QUATTROCCHI KWOK
ARCHITECTS

PARKWAY HEIGHTS MIDDLE SCHOOL MODERNIZATION – PHASE II
PROJECT 01-18

Addendum 02

FEBRUARY 21, 2018

SHEET NUMBER
ADD 02
02.01
C0.1

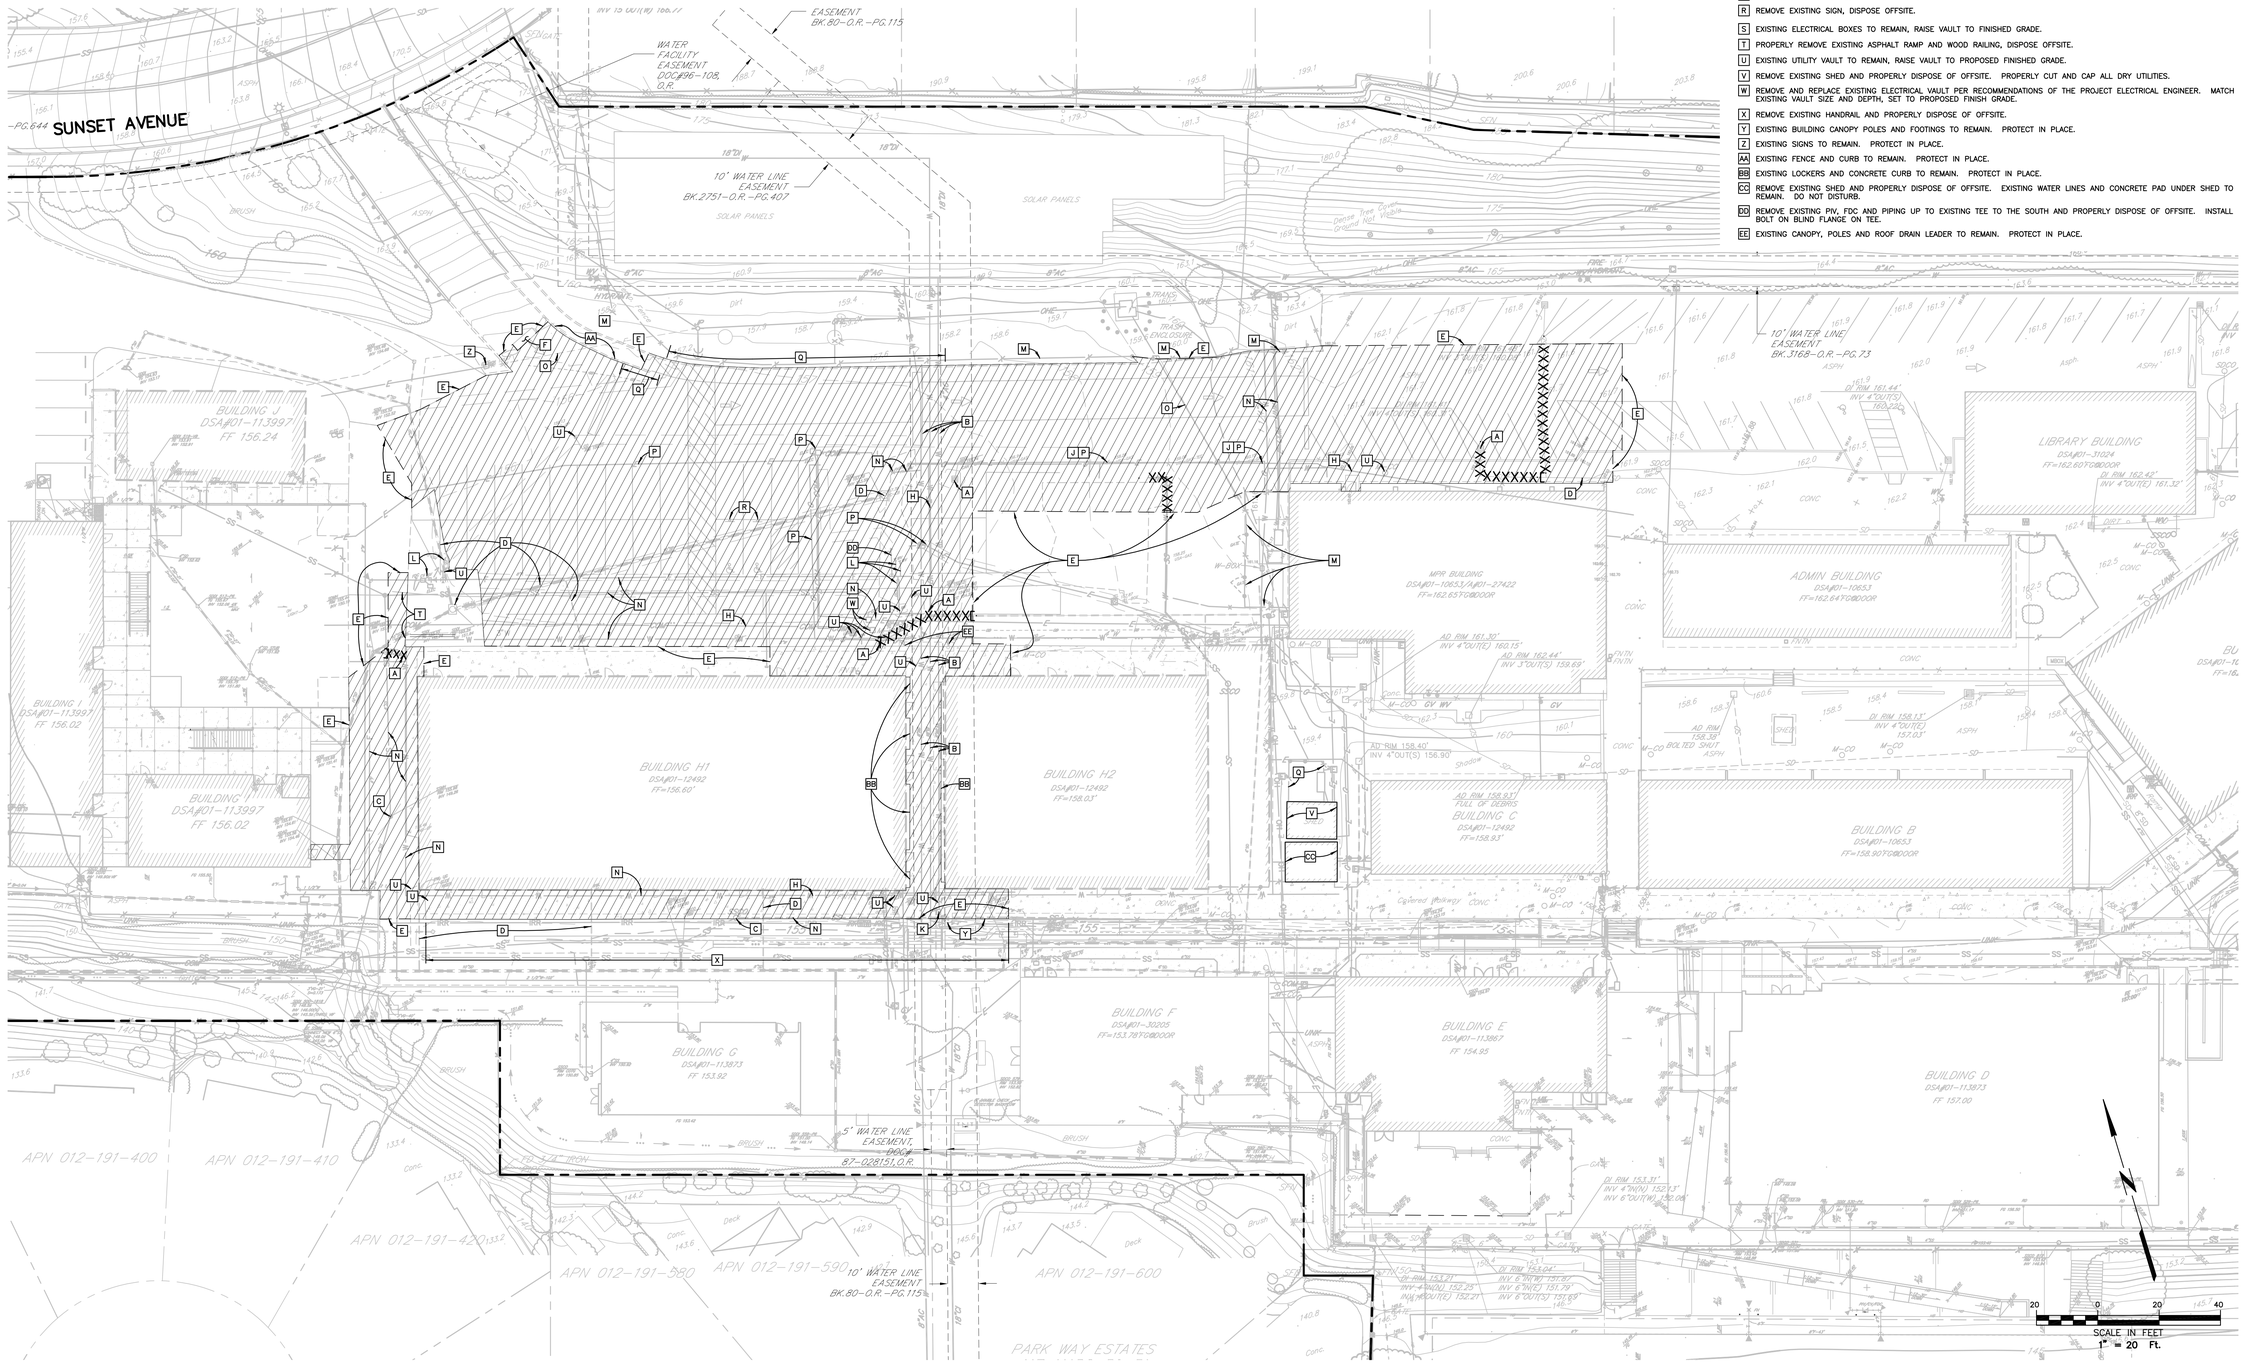
Item No. 2.05
Sheet C0.1 Abbreviations, Legend & Notes
There are no changes to this sheet, from those indicted on sheet C0. See ADD 02.01

SHEET NUMBER
ADD 02
02.02
C1.1

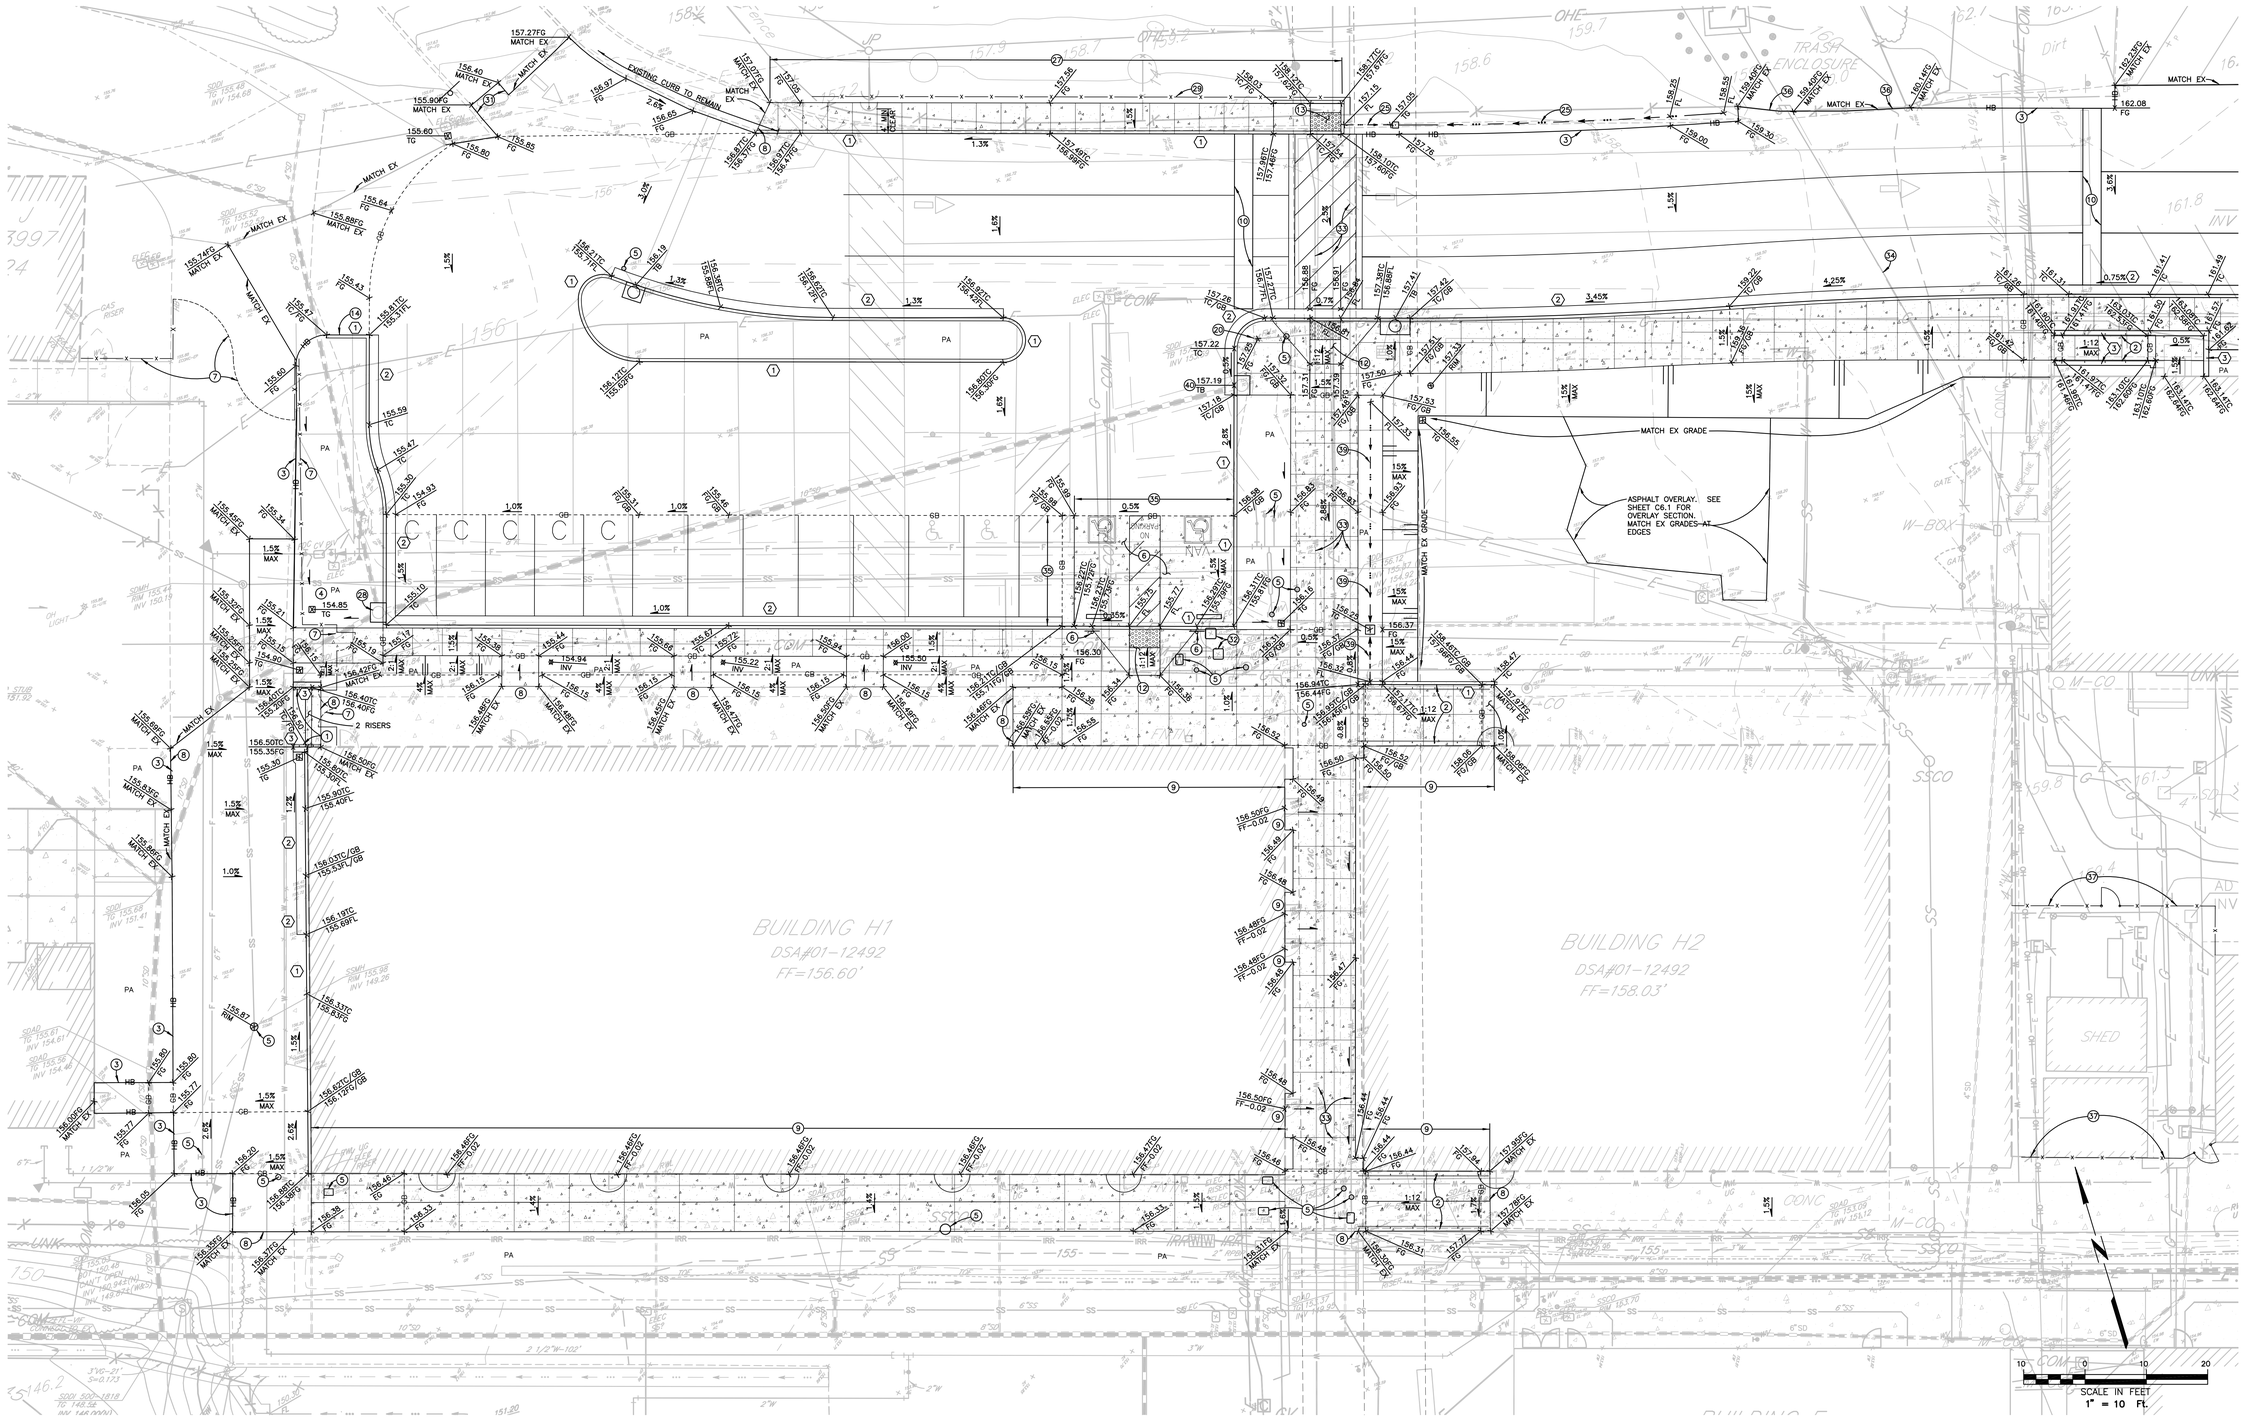
Item No. 2.06
Sheet C1.1 Demolition Plan
Modifications from sheet C1 include removed demotion work in courtyard area on north side of building H2. Maintain existing fencing around electrical equipment on the east side of the courtyard. See ADD 02.02

SHEET NUMBER
ADD 02
02.04
C3.1

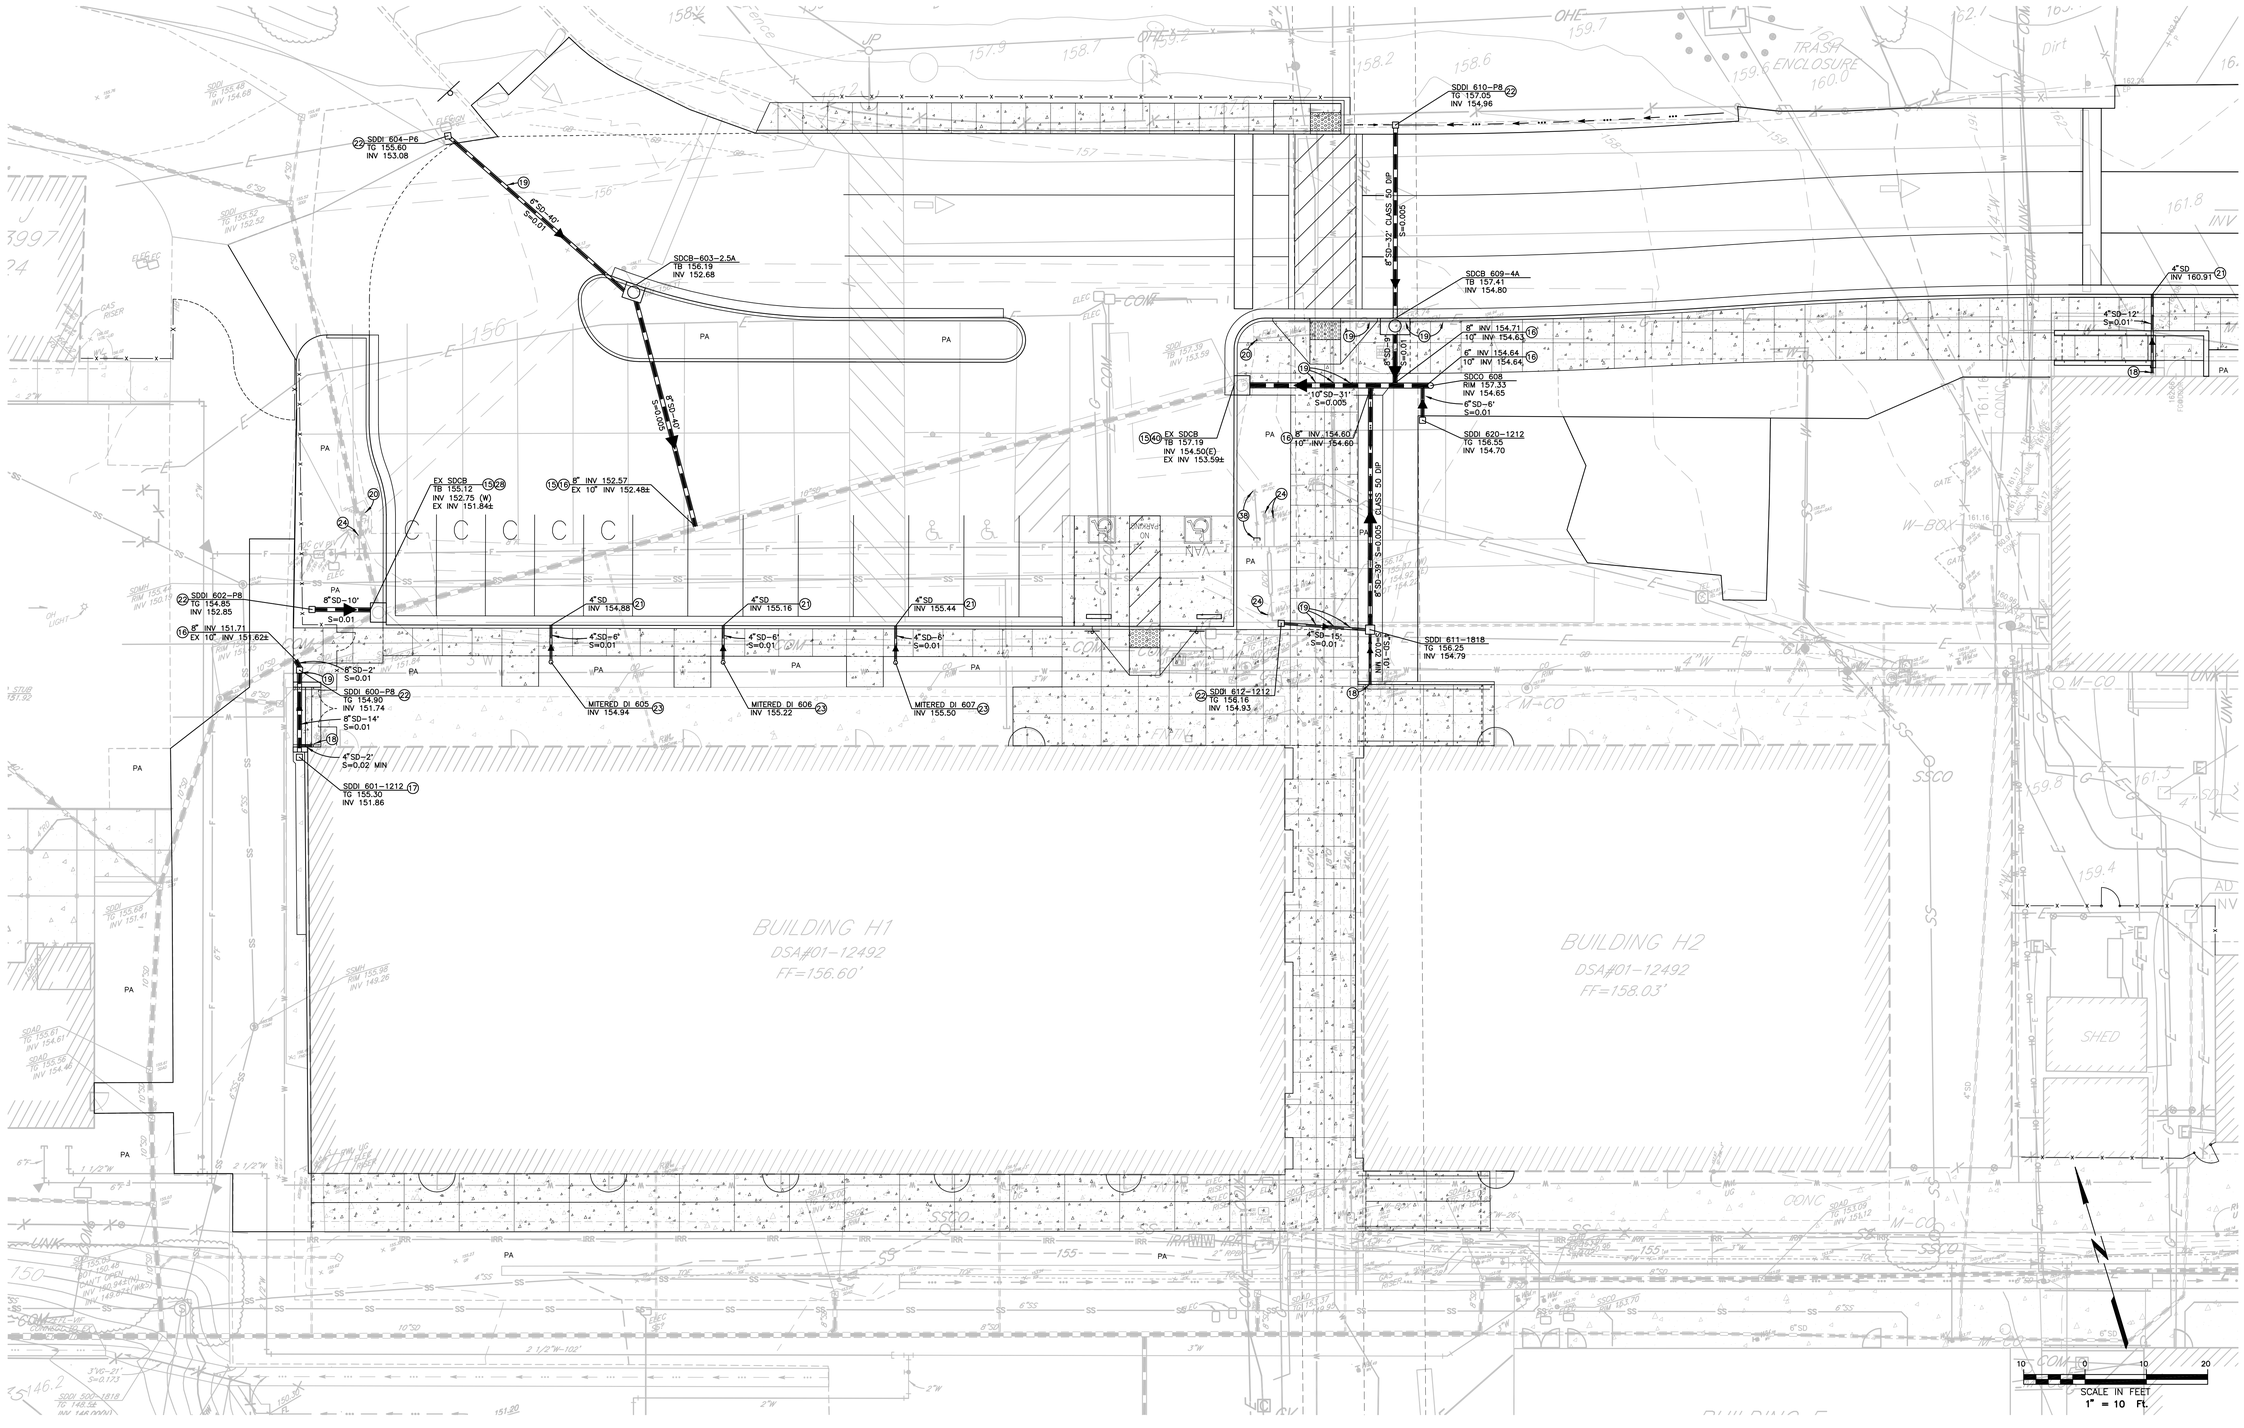
Item No. 2.08
Sheet C3.1 Grading Plan
Modifications from sheet C3 include remove courtyard concrete paving, type 4 18" wide curb, remove curbs around each tree planter box, remove stairs and handrails on north side of courtyard, add concrete valley gutter on west side of courtyard, add courtyard asphalt pavement conform from back of sidewalk to existing asphalt pavement within the courtyard. Lower curb grades along passenger drop off area on the north and west sides of the courtyard. See ADD 02.04
